To: Prospective Bidders
From: Wold Architects and Engineers
Date: April 13, 2017
Comm. No: 173011

Subject: Addendum No. 1 for Bidding Documents for: Huntley CSD No. 158
Conley Elementary School
Chiller and RTU Replacement

This Addendum consists of two (2) typed sheets and attachments:
General: Pre-Bid Meeting Sign-In Sheet
Drawings: M0.11, M0.21, M1.21

1. SHEET M0.11 – CHILLER MECHANICAL DEMOLITION PLAN

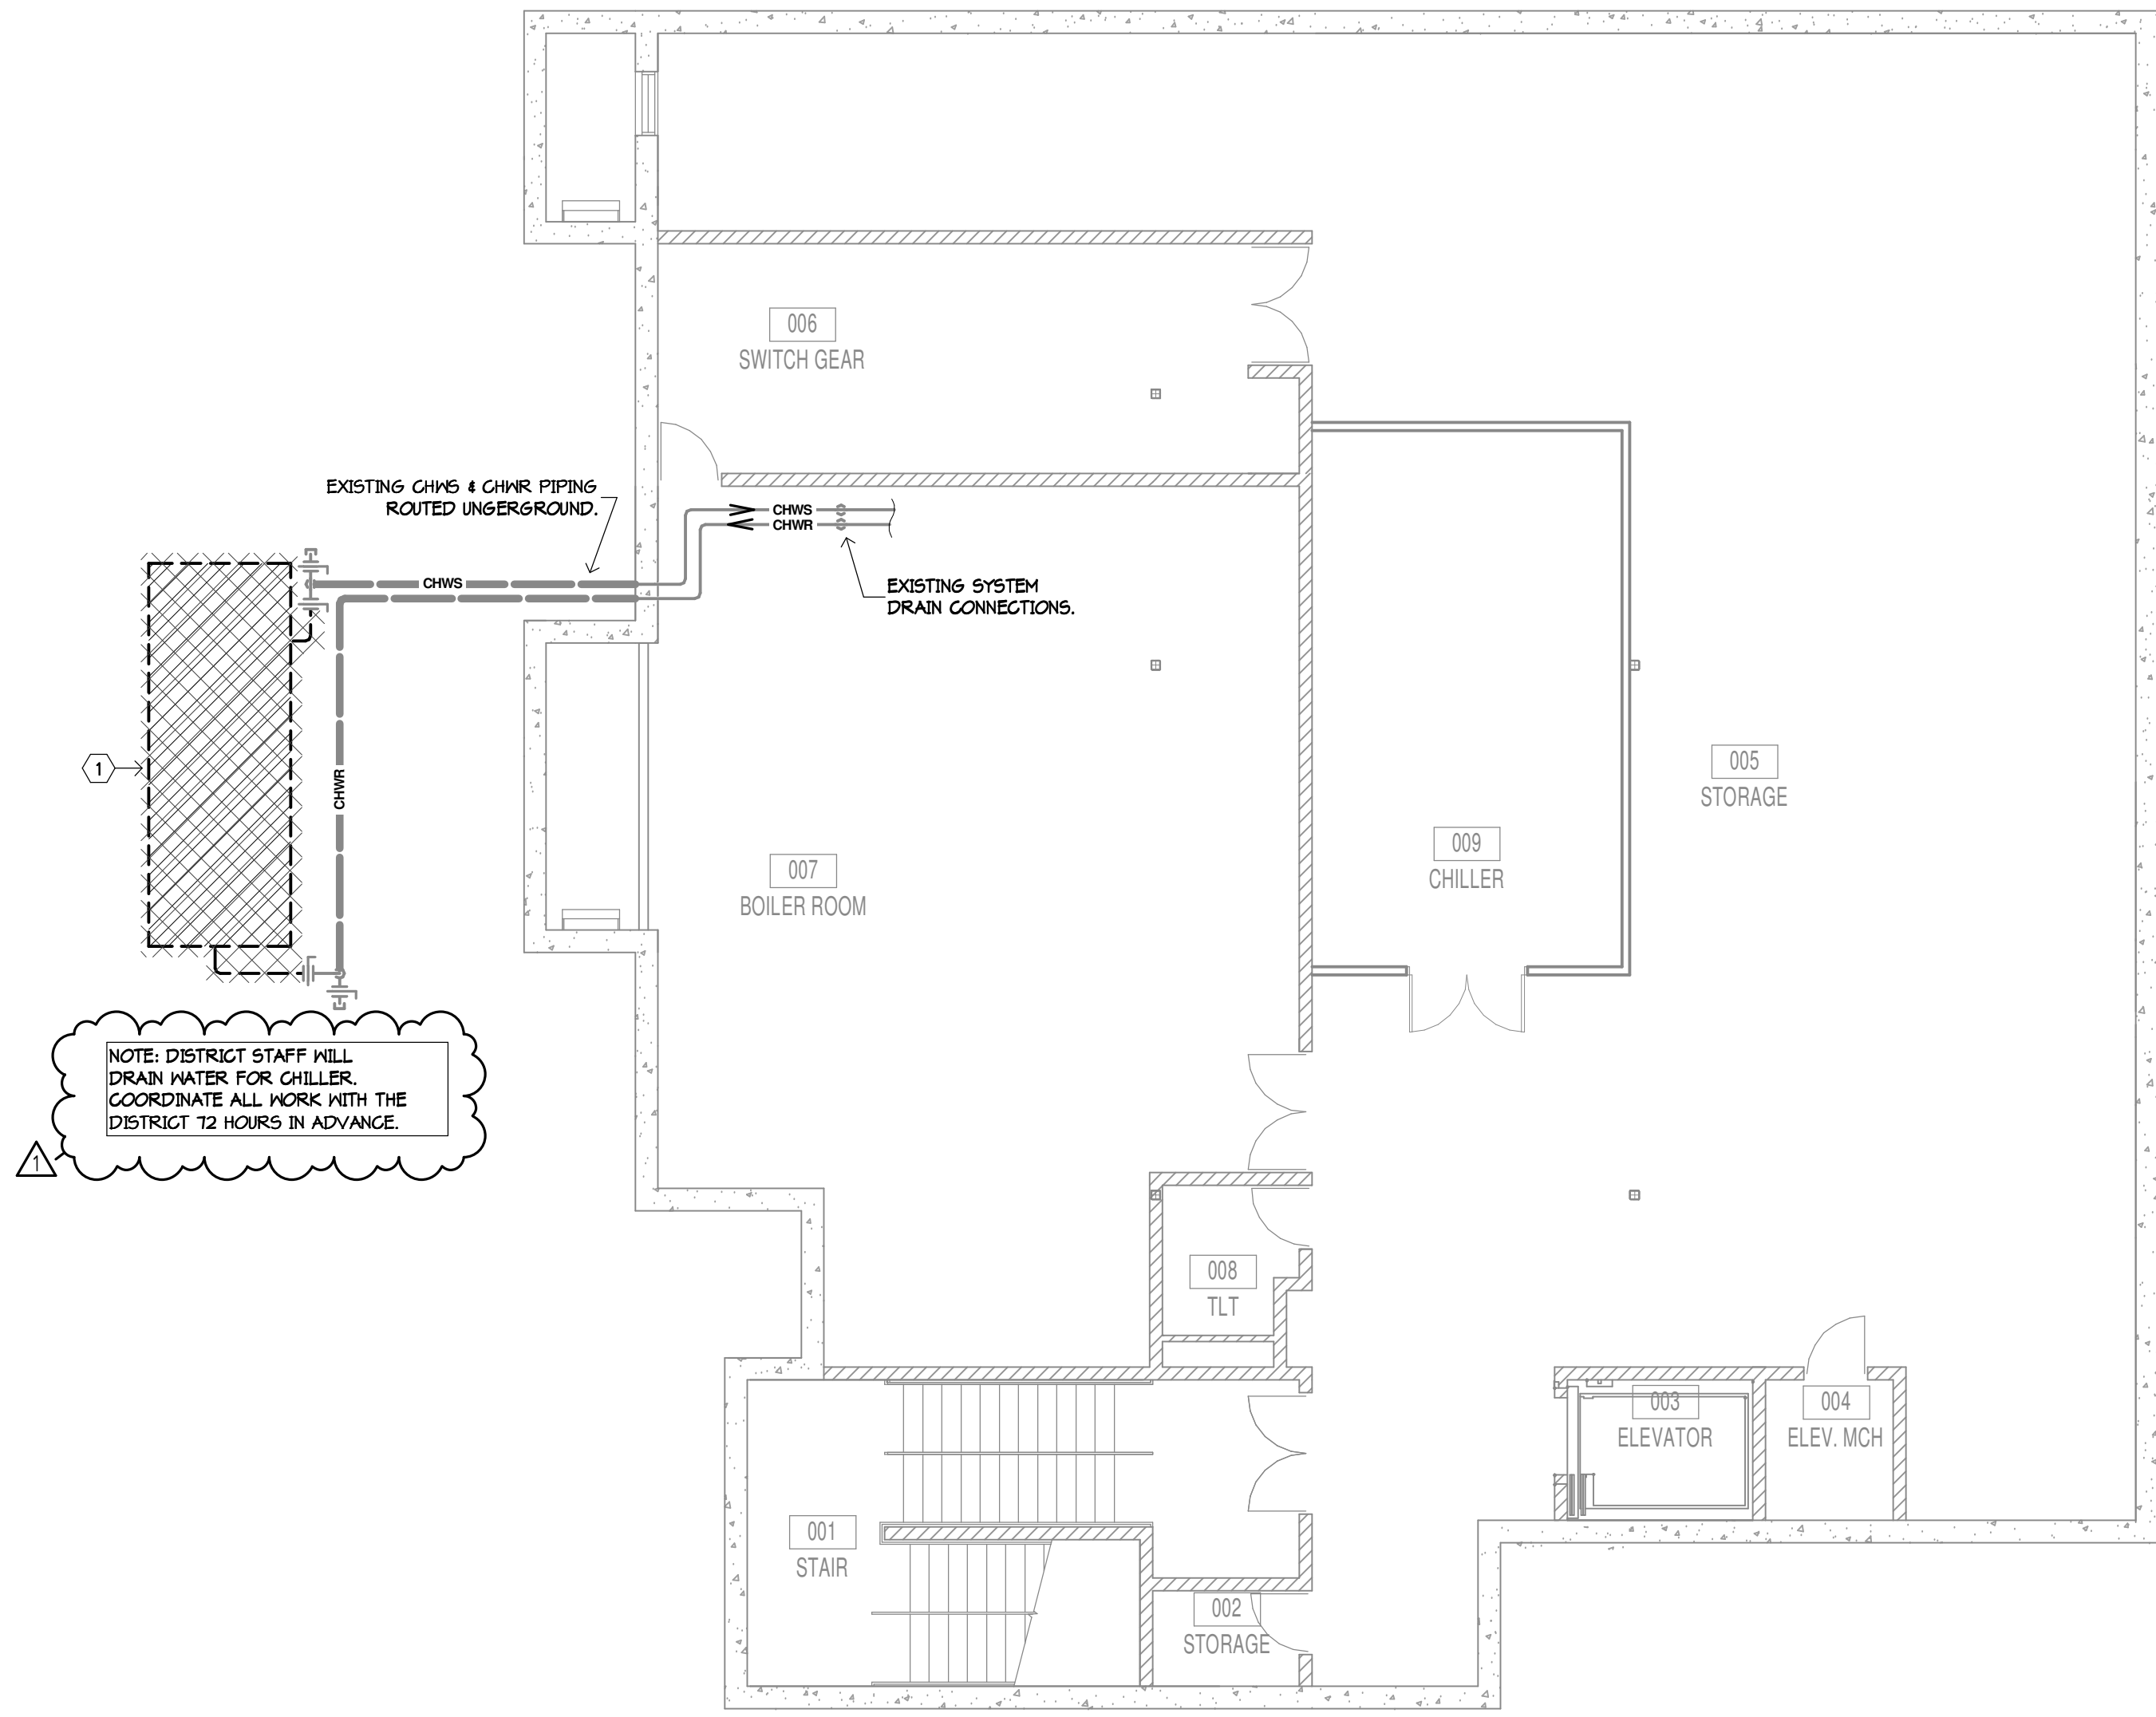
- A. Sheet reissued this Addendum to indicate District Staff will drain the chilled water system prior to equipment demolition. The Contractor will be responsible for flushing/filling the system as specified.

- REMOVE EXISTING AIR-COOLED CHILLER. DISCONNECT ALL EXISTING HYDRONIC PIPING AND ASSOCIATED POWER AND CONTROL WIRING. PREPARE EACH FOR RECONNECTION TO NEW EQUIPMENT.
- REMOVE EXISTING ROOFTOP UNIT. DISCONNECT ALL EXISTING HYDRONIC PIPING, DUCTWORK, AND ASSOCIATED POWER AND CONTROL WIRING. PREPARE EACH FOR RECONNECTION TO NEW EQUIPMENT.
- REMOVE EXISTING LIGHTNING PROTECTION DEVICES AND REINSTALL ON NEW EQUIPMENT.

2. SHEET M0.21 – ROOFTOP UNIT MECHANICAL DEMOLITION PLAN

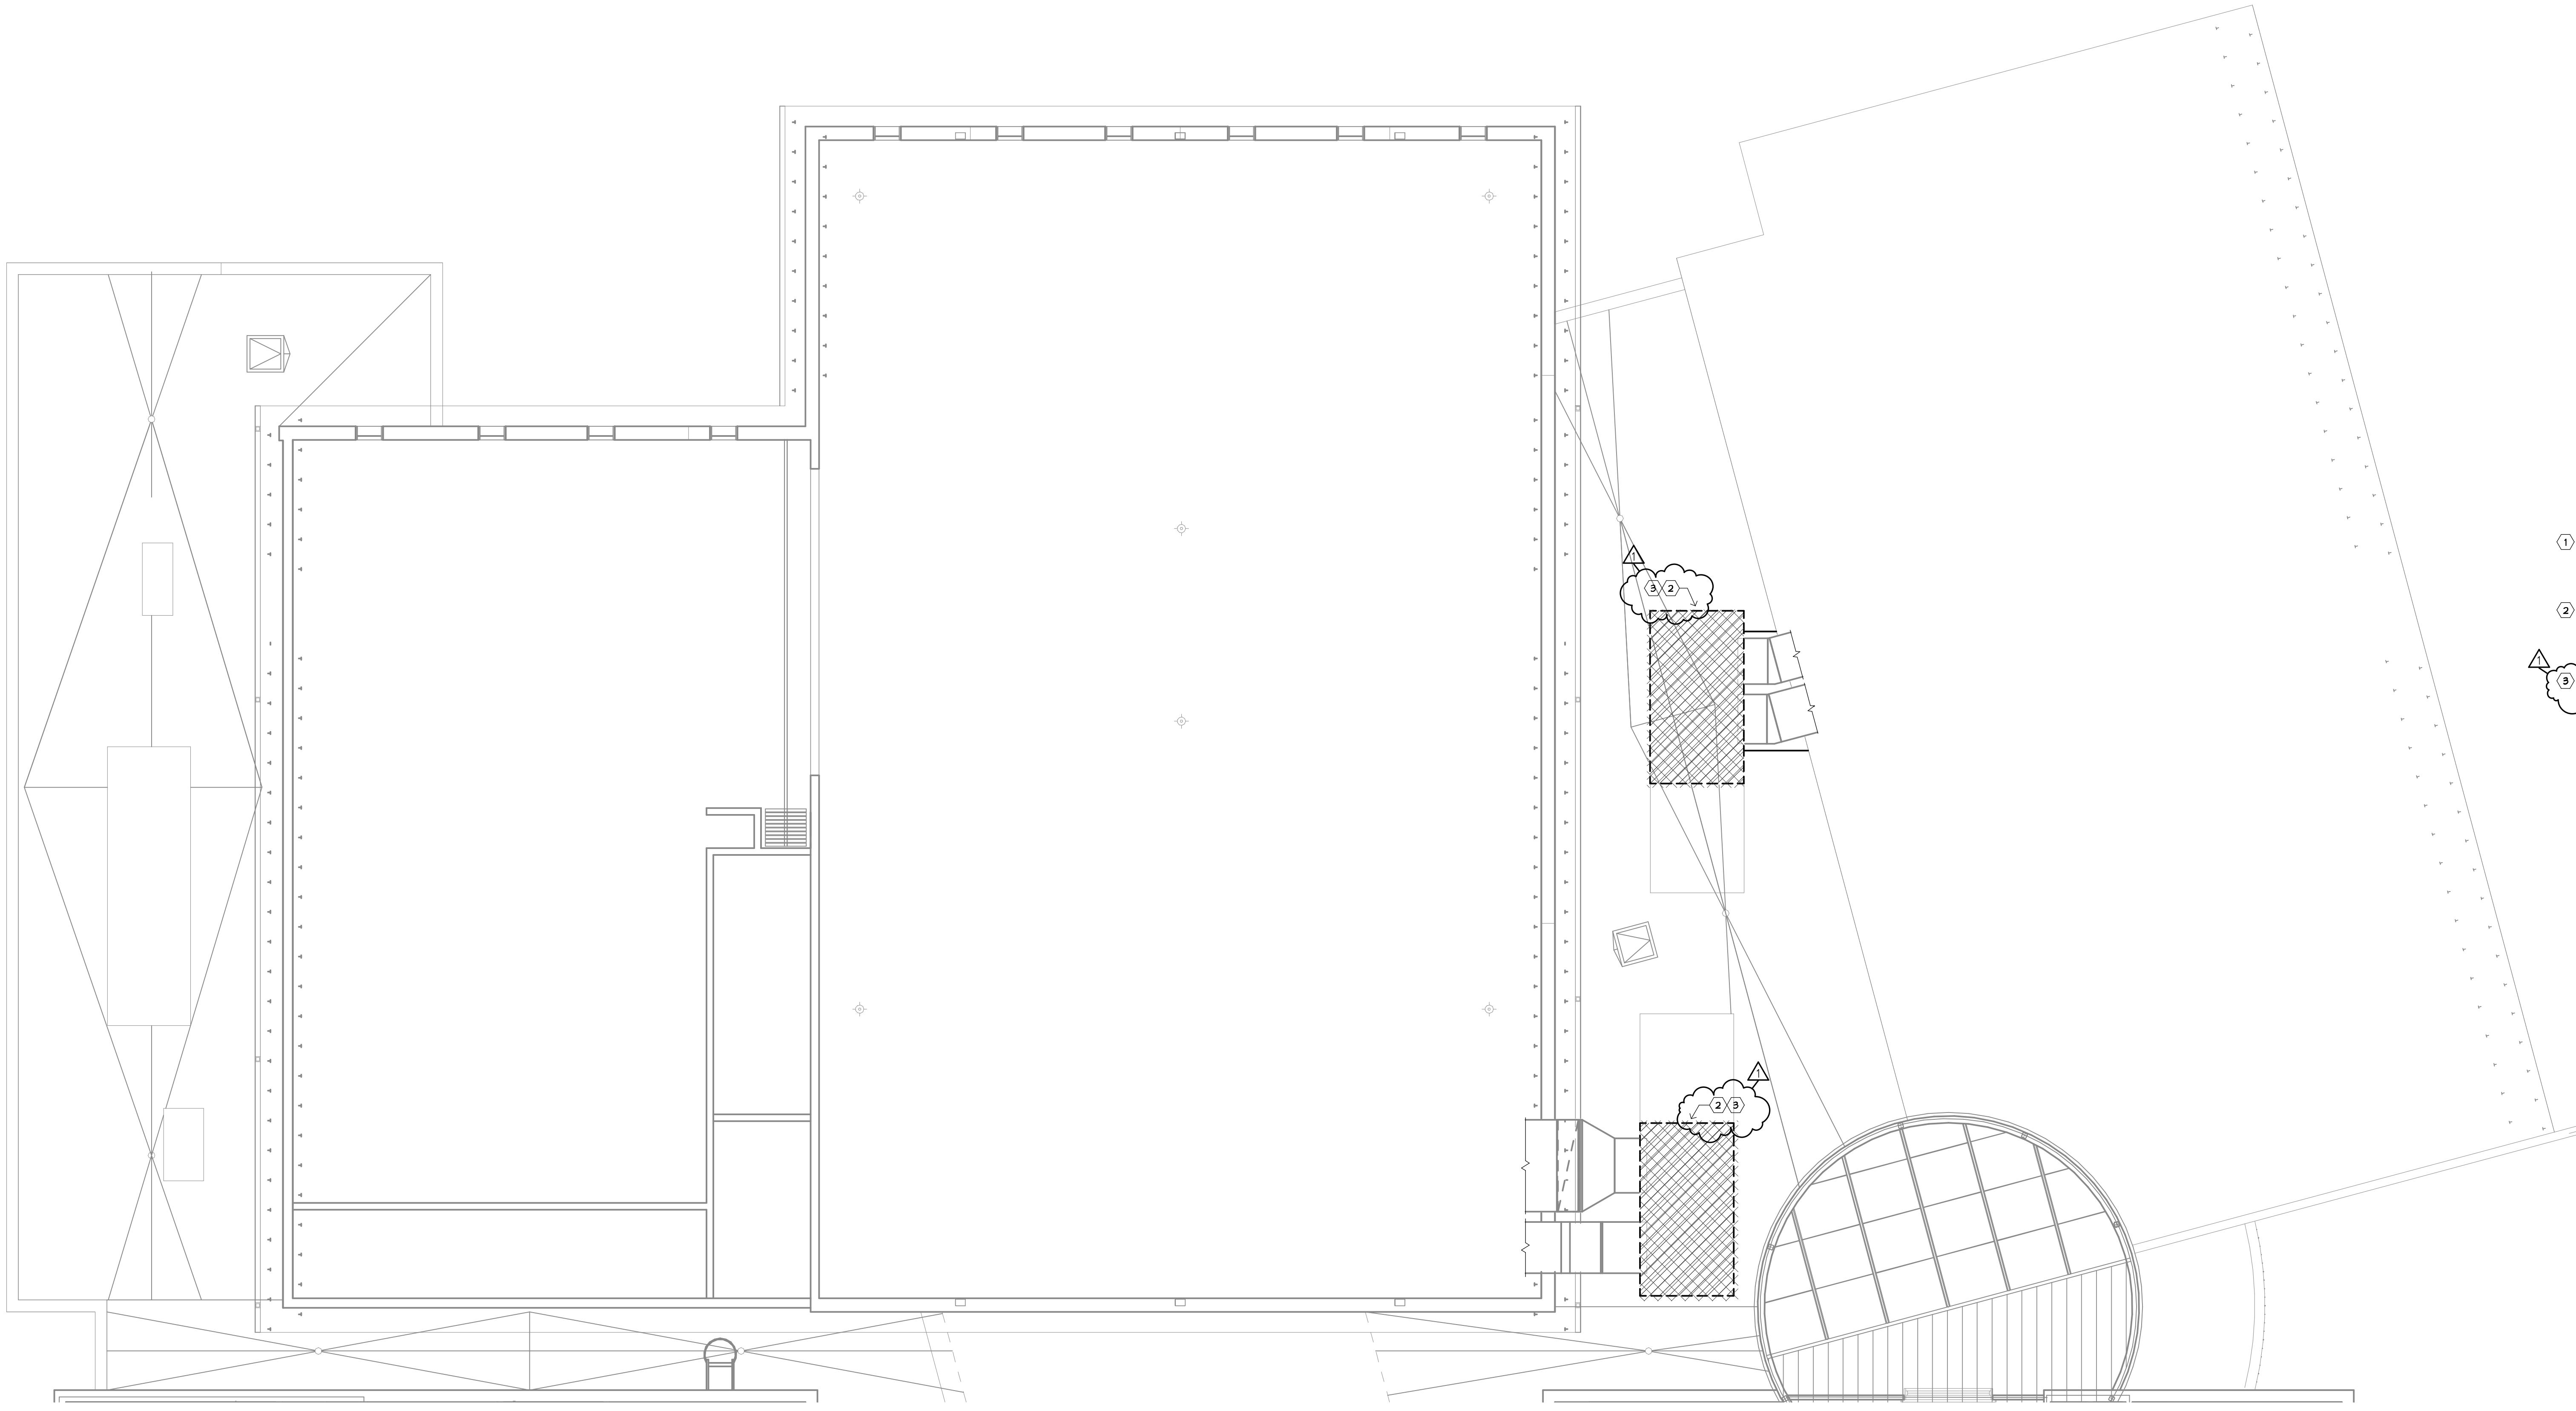
- A. Sheet reissued this Addendum to indicate removal and reinstallation of existing lightning protection devices at equipment.

3. REMOVE EXISTING LIGHTNING PROTECTION DEVICES AND REINSTALL ON NEW EQUIPMENT.

3. SHEET M1.21 – ROOFTOP UNIT MECHANICAL NEW WORK PLAN

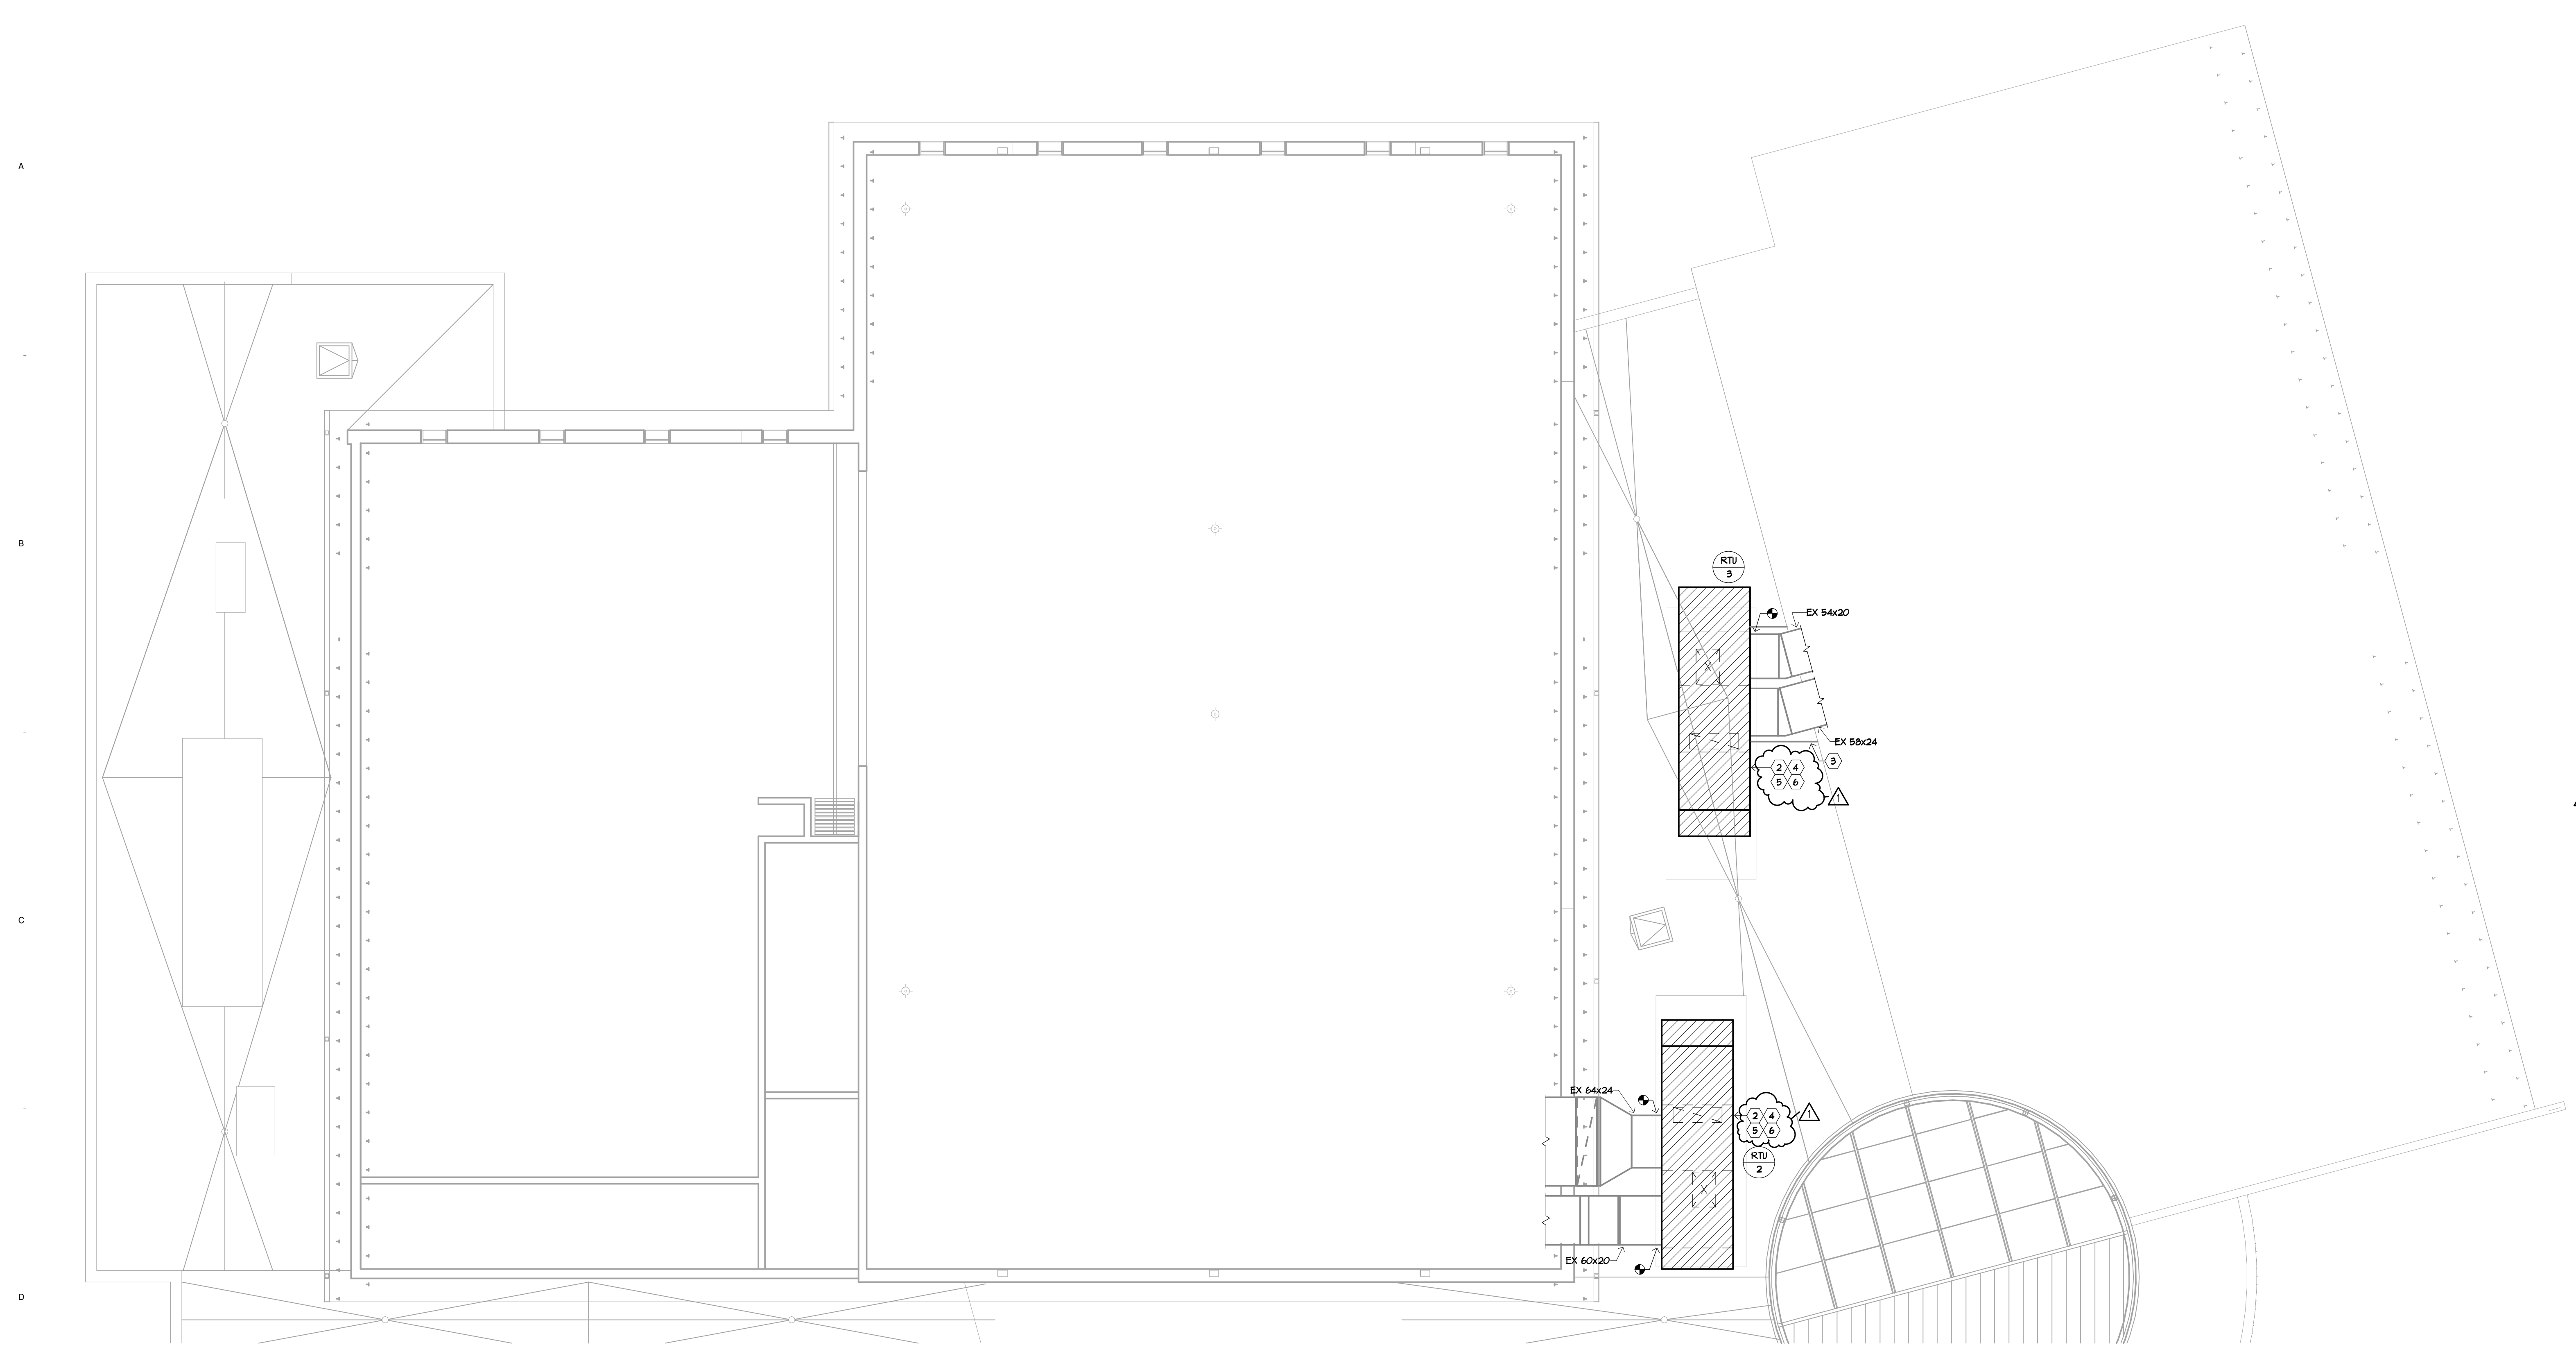
- A. Sheet reissued this Addendum to indicate removal and reinstallation of existing lightning protection devices at equipment, to indicate application of primer paint to all existing metal deck surfaces uncovered during construction, and to revise Rooftop Unit Schedule notes.

5. REINSTALL EXISTING LIGHTNING PROTECTION DEVICES (CABLES, RODS, ETC.) ON NEW EQUIPMENT.
6. ALL METAL DECK SURFACES INVOLVED DURING THE REMOVAL/INSTALLATIONS OF EQUIPMENT SHALL BE PAINTED WITH A RUST-INHIBITIVE WATERBORNE ACRYLIC PRIMER BEFORE BEING CONCEALED.
